MODERNIZATION AT CORCORAN HIGH SCHOOL – SCIENCE BUILDING

**CORCORAN UNIFIED SCHOOL DISTRICT
CORCORAN, KINGS COUNTY, CALIFORNIA**

ADDENDUM NO. 1

RE: Electrical List of Changes for Addendum #1

TITLE
BUILDING 900
FIRE ALARM PLANS

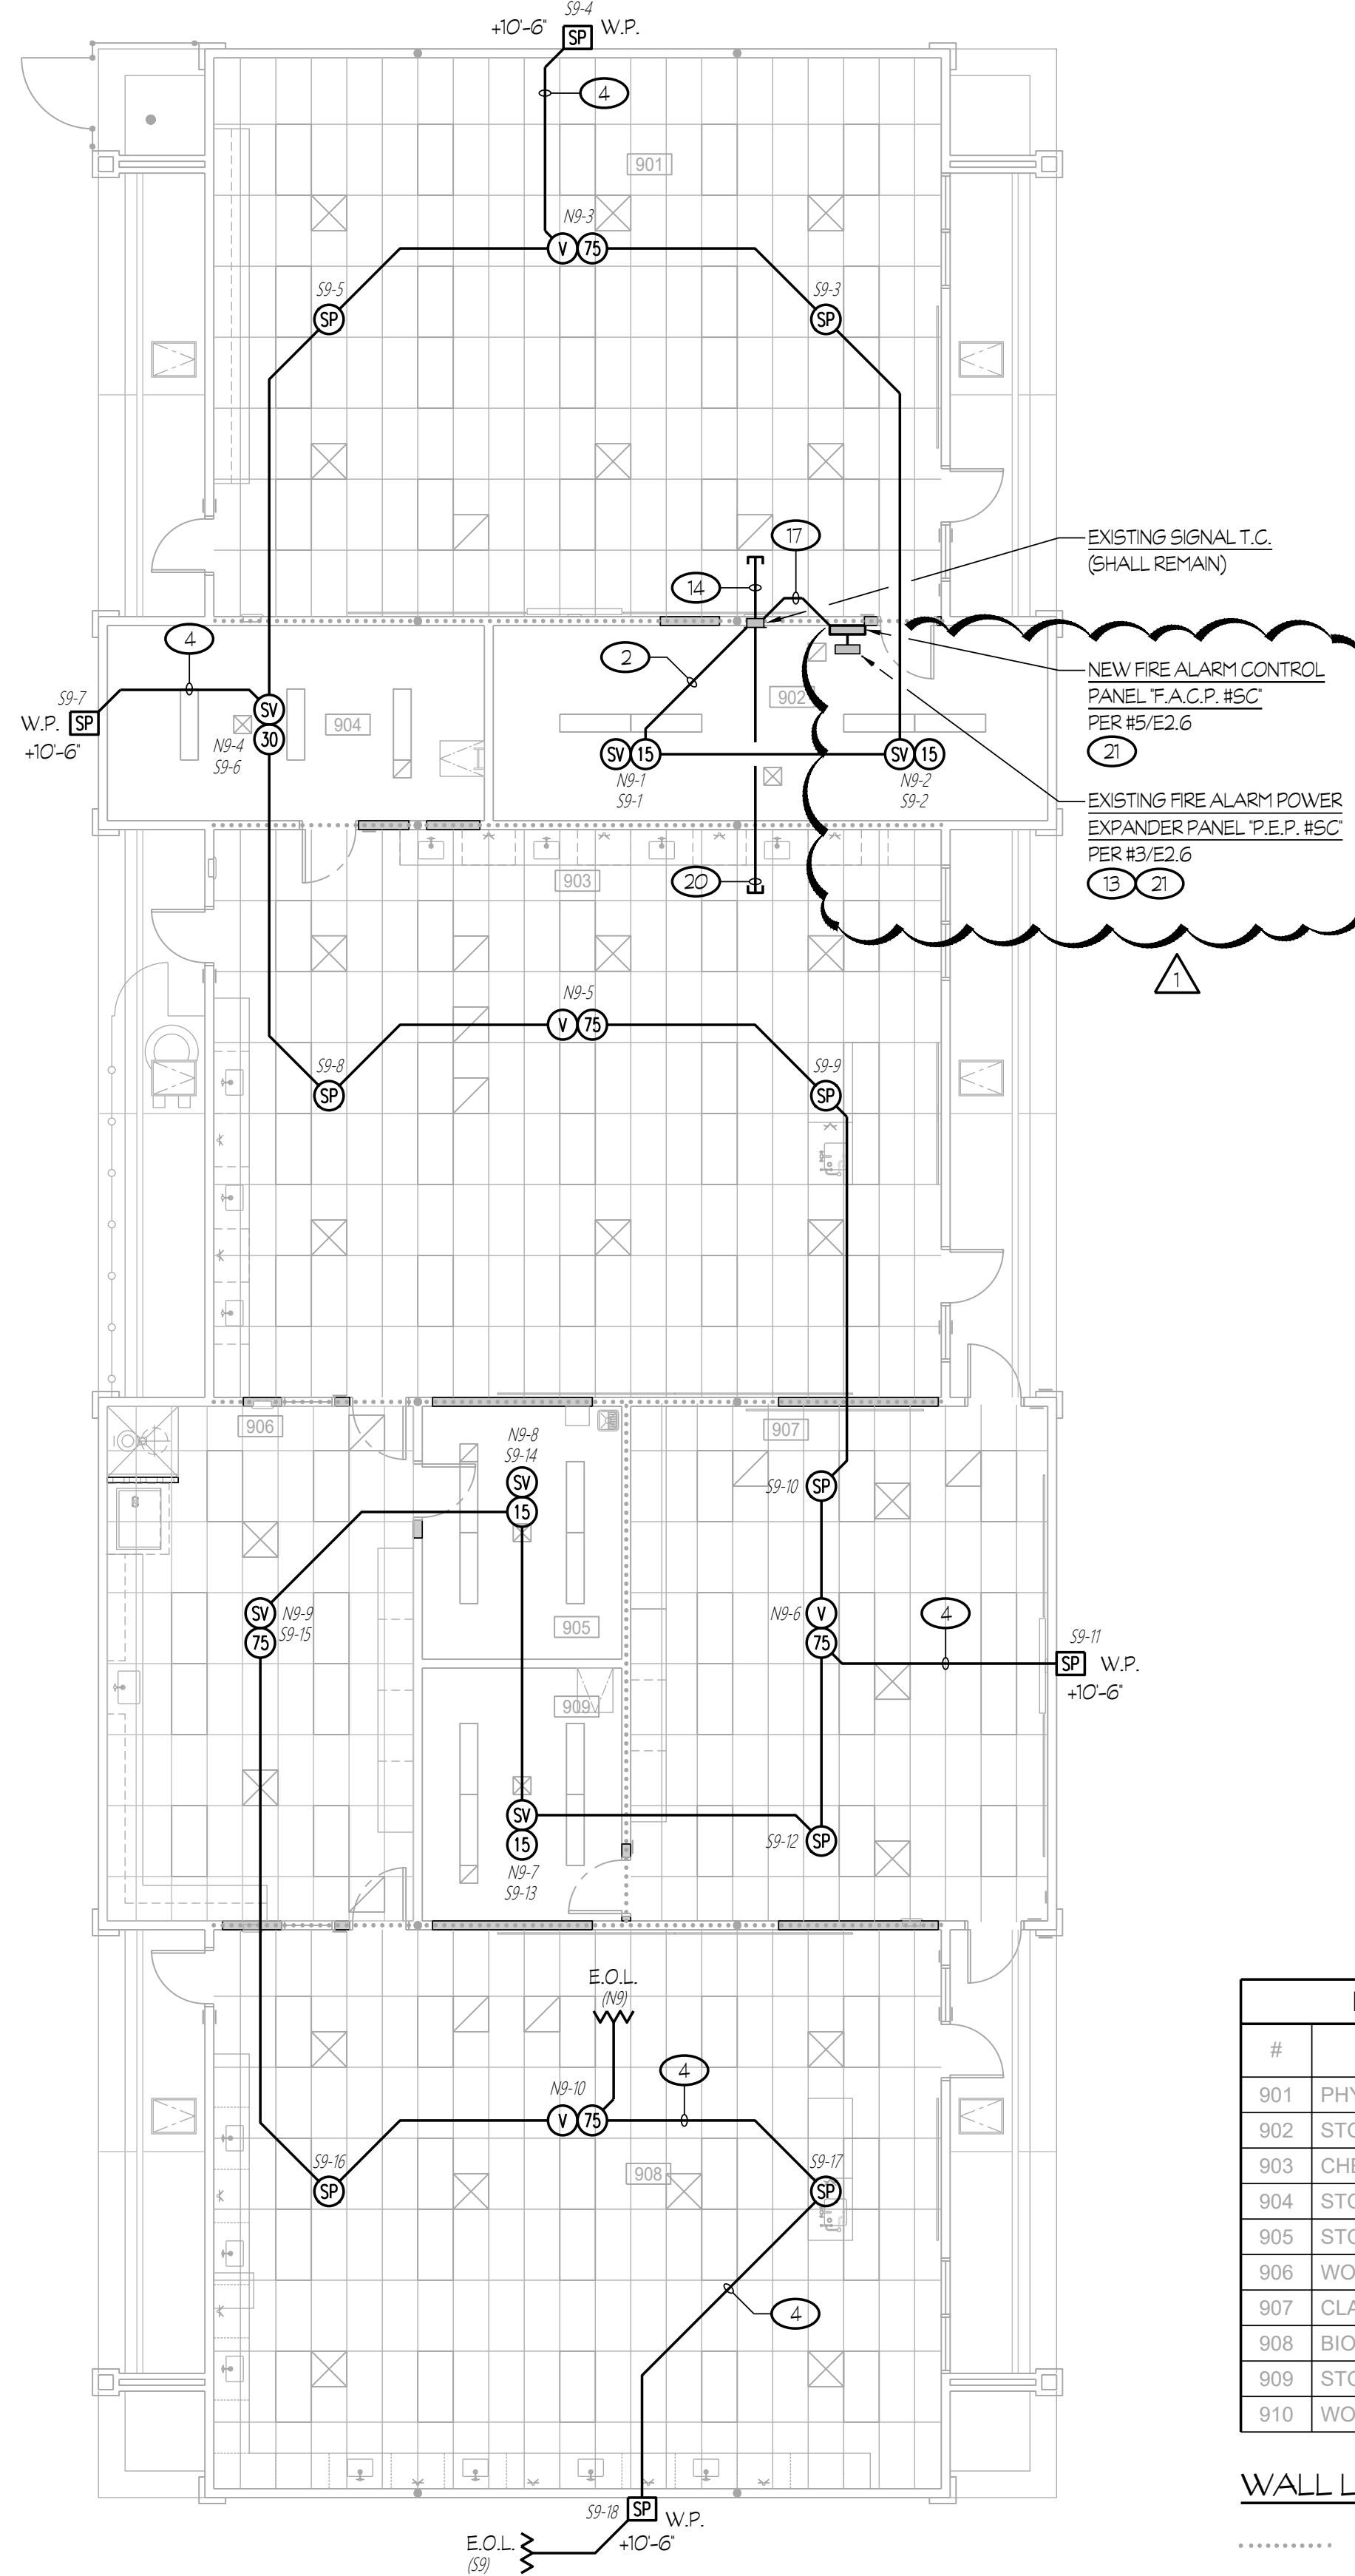
- Added keynotes number 4 – 6	1
	- Added FACP #SC and PEP #SC	1
E1.10	- Added keynote #21	1
	- Added FACP #SC	1
E2.1	- Removed FACP #NA, FACP #7, UFAC, and PEP#- from the fire alarm equipment legend	1

- 20 1/2" - 2 #14.
- 21 MOUNT THE EXISTING FIRE ALARM POWER EXPANDER PANEL 'P.E.P. #5C' ABOVE THE NEW FIRE ALARM CONTROL PANEL 'F.A.C.P. #5C'.

TITLE
FIRE ALARM SYSTEM
MAIN RISER DIAGRAM

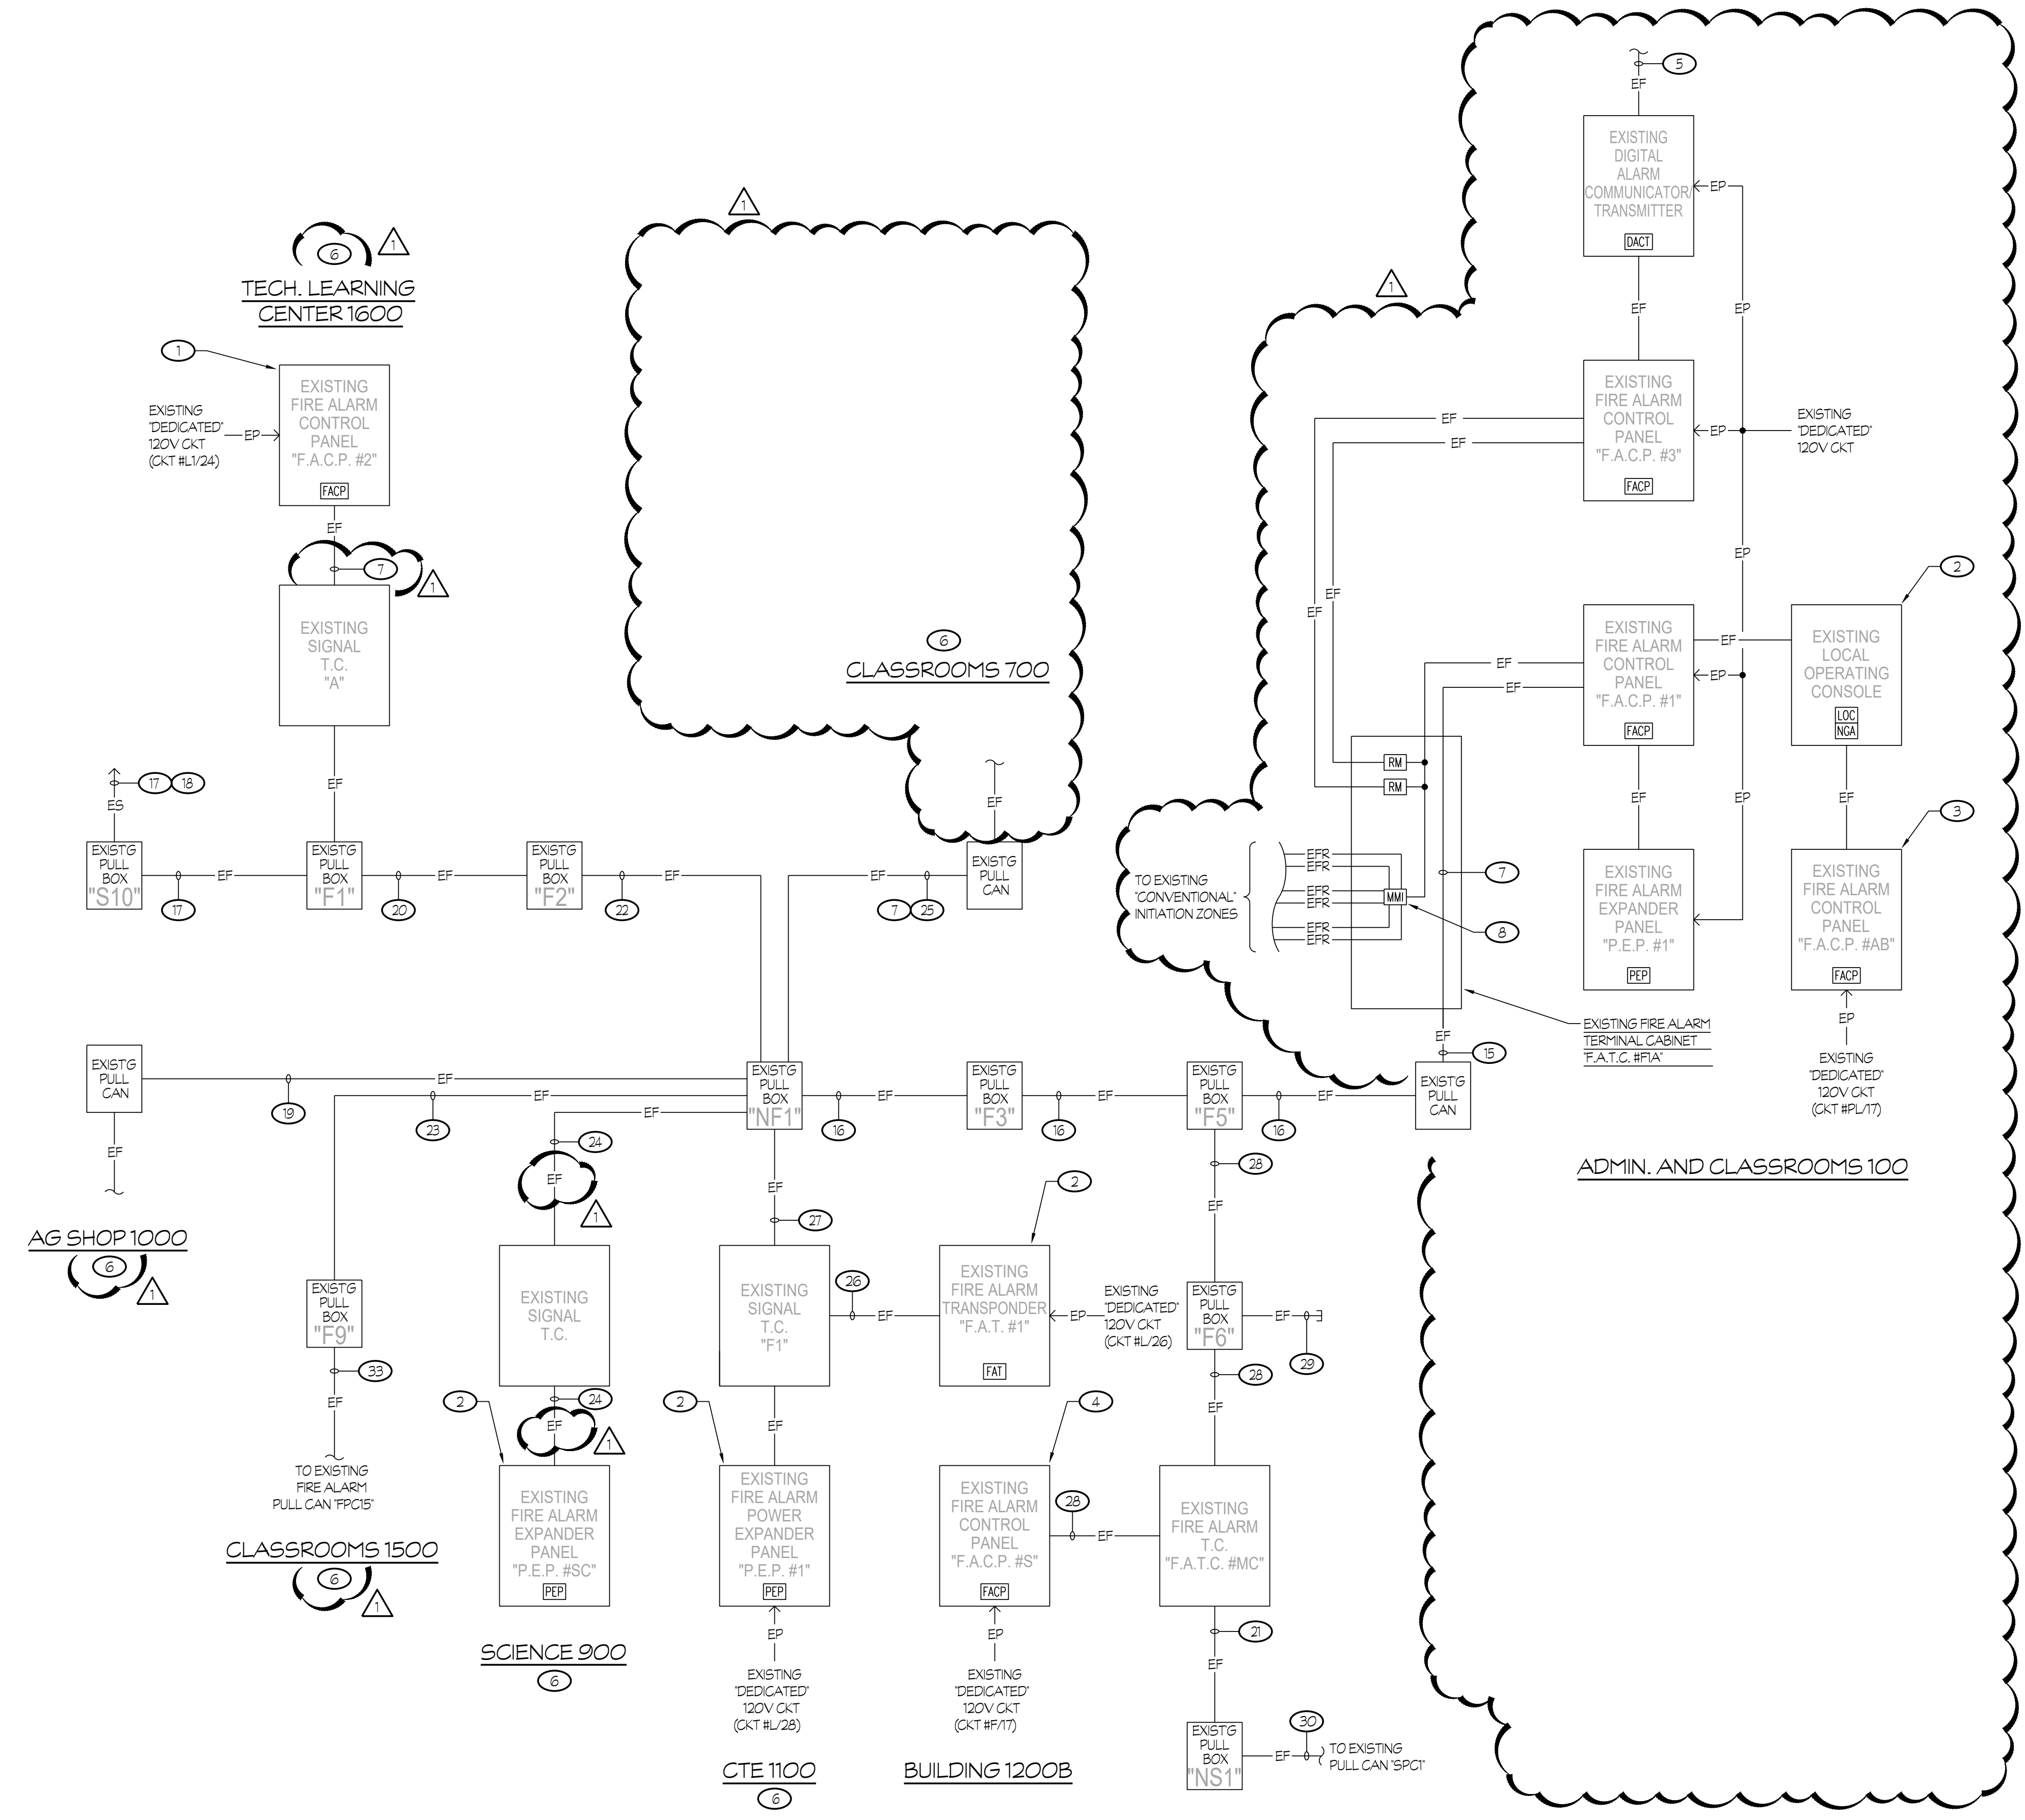
- Removed notes G and H	1
	- Added FACP #SC to the fire alarm equipment legend	1
E2.2	- Revised the signaling line circuit, notification appliance circuit, and speaker circuit schedules	1
E2.3	- Removed and/or replaced fire alarm equipment shown at bldgs. 700 and 100	1

- Added keynote #6 to bldgs. 1000, 1500, and 1600	1
	- Adjusted conduit at bldg 900 from EFR to EF	1
	- Replaced keynotes #5, 6, 21–28, 30, and 33	1
	- Removed keynotes #9-14, 31, 32, and 34. Aforementioned keynotes now shown as “not in use”.	1
E2.4	- Replaced keynotes 7-14 and 16-18	1

TITLE
PARTIAL FIRE ALARM SYSTEM
RISER DIAGRAM

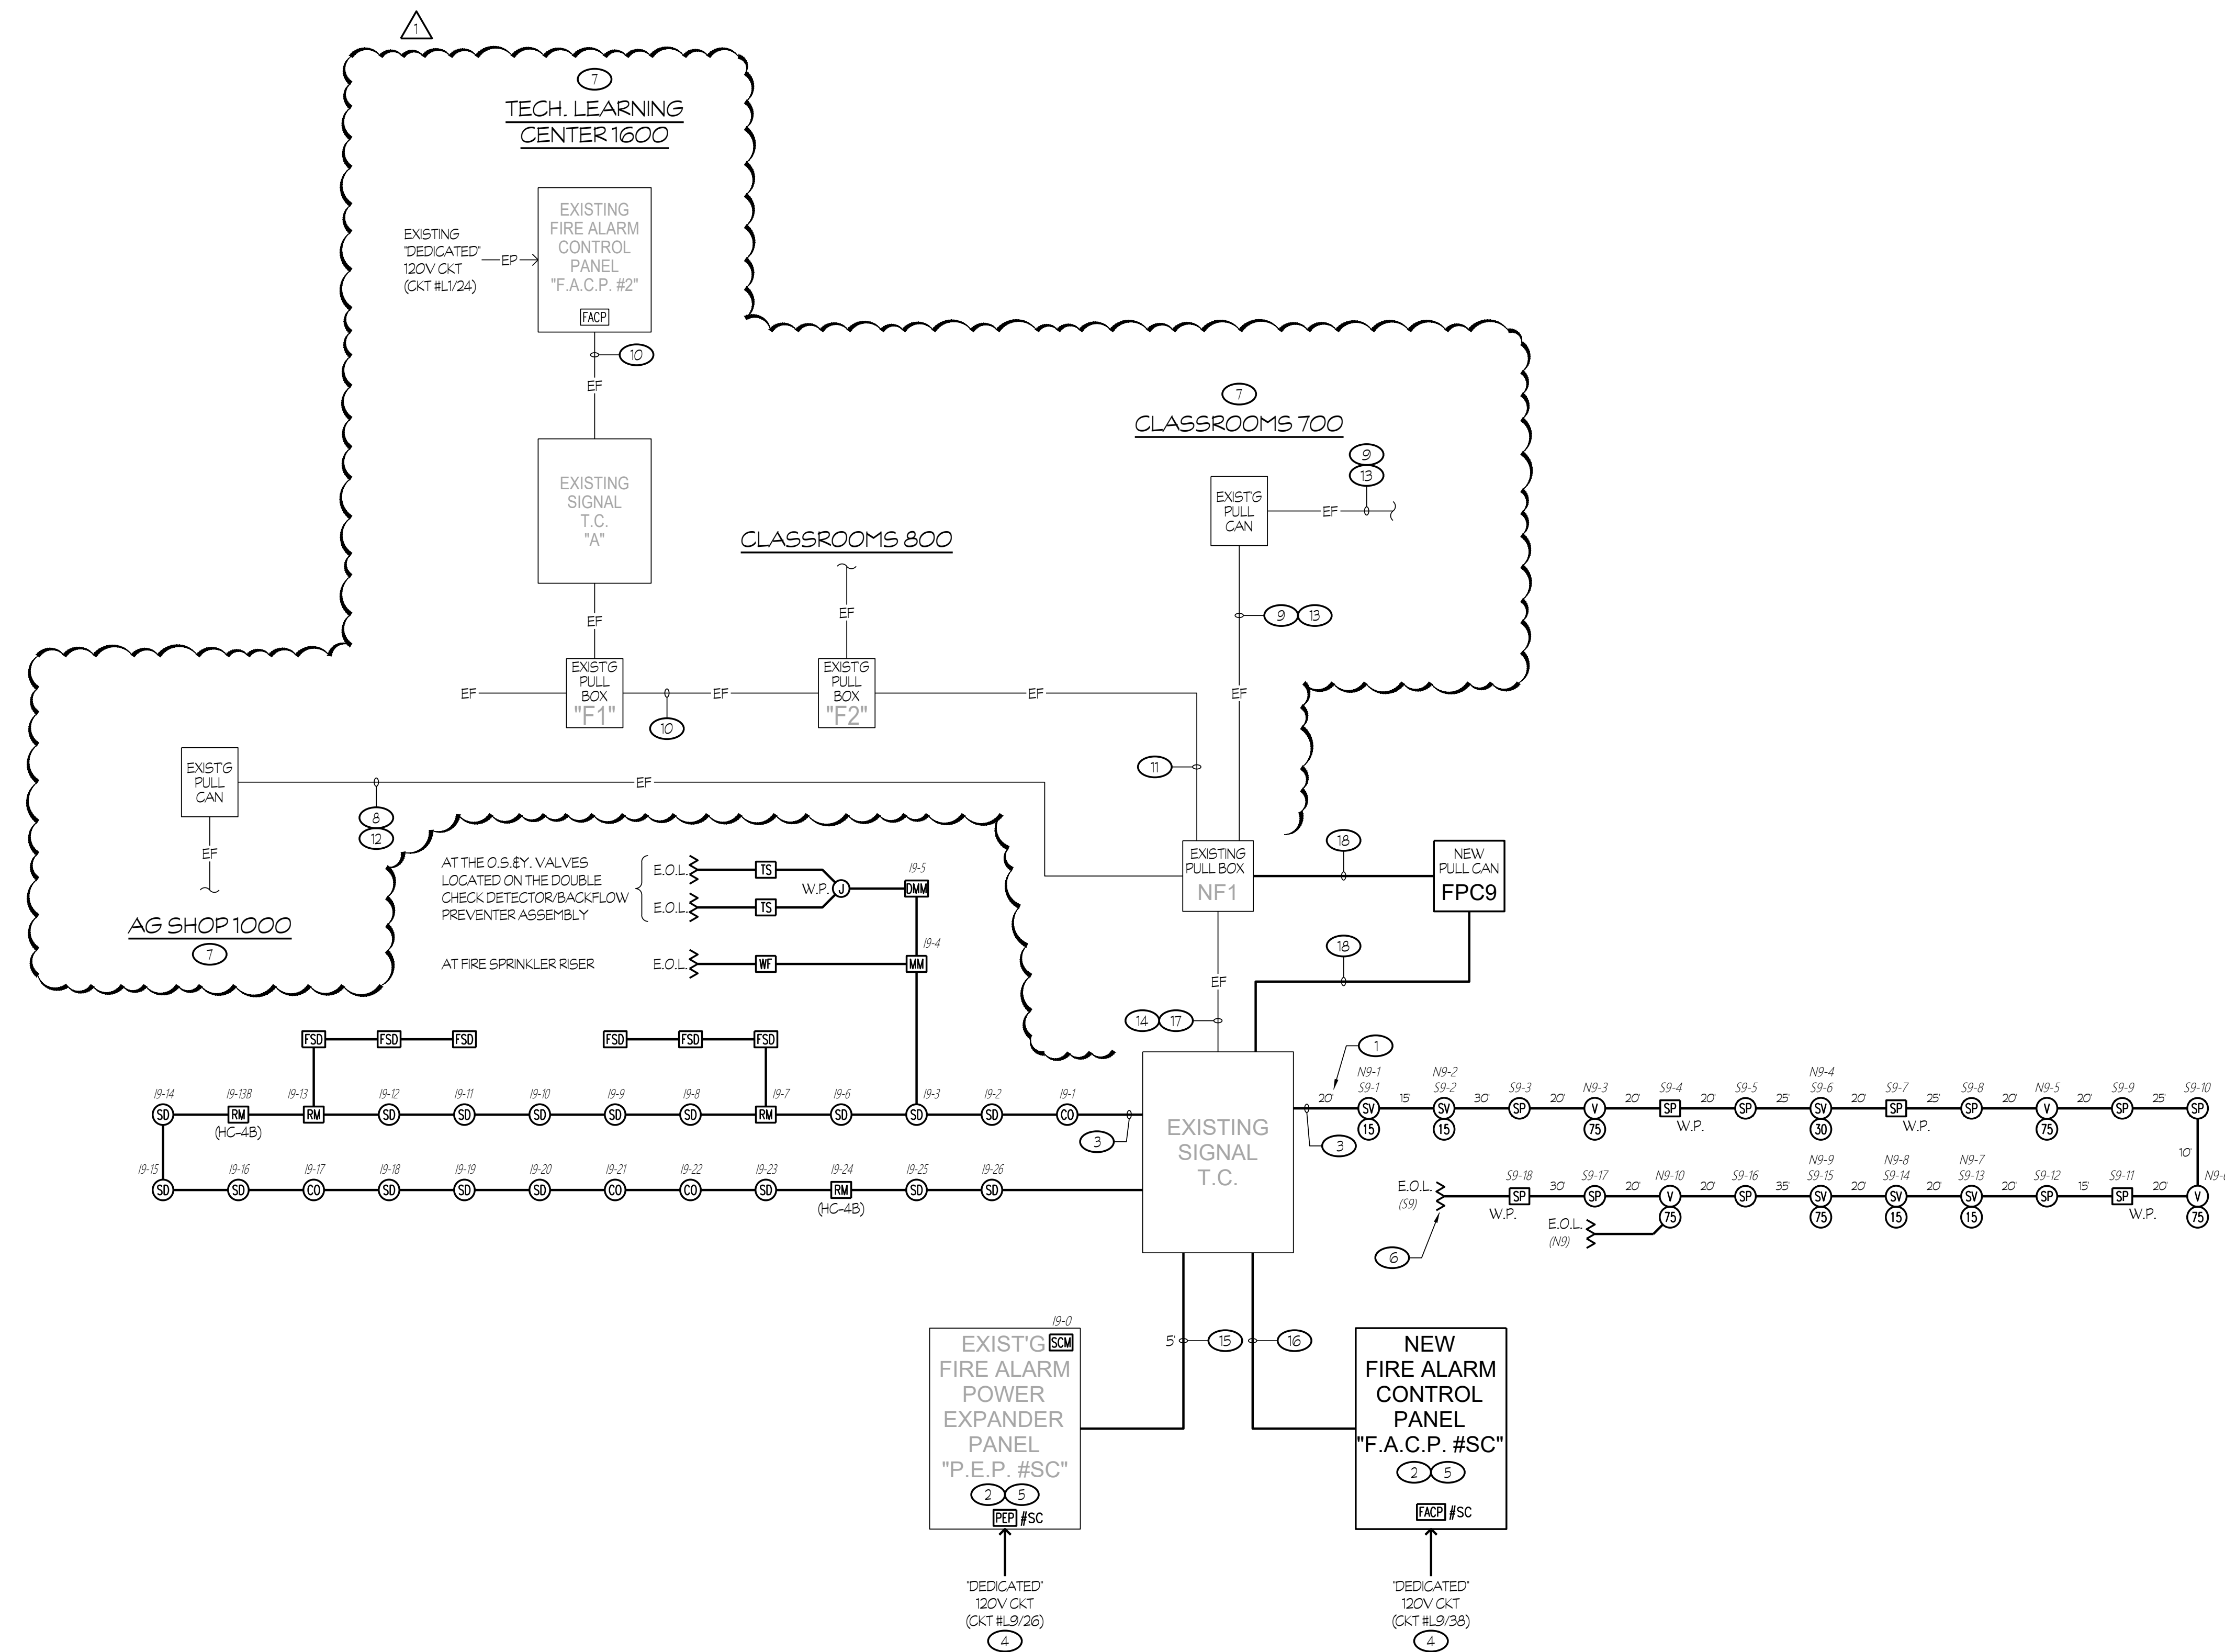
- Removed and Replaced fire alarm equipment shown at buildings 700, 800, 1000	1
	- Removed pull boxes NF7 - NF9, and pull cans FPC7, FPC8, FPC10	1
	- Added fire alarm equipment shown at bldg 1600	1
E2.5	- Revised the PEP #SC battery calcs	1
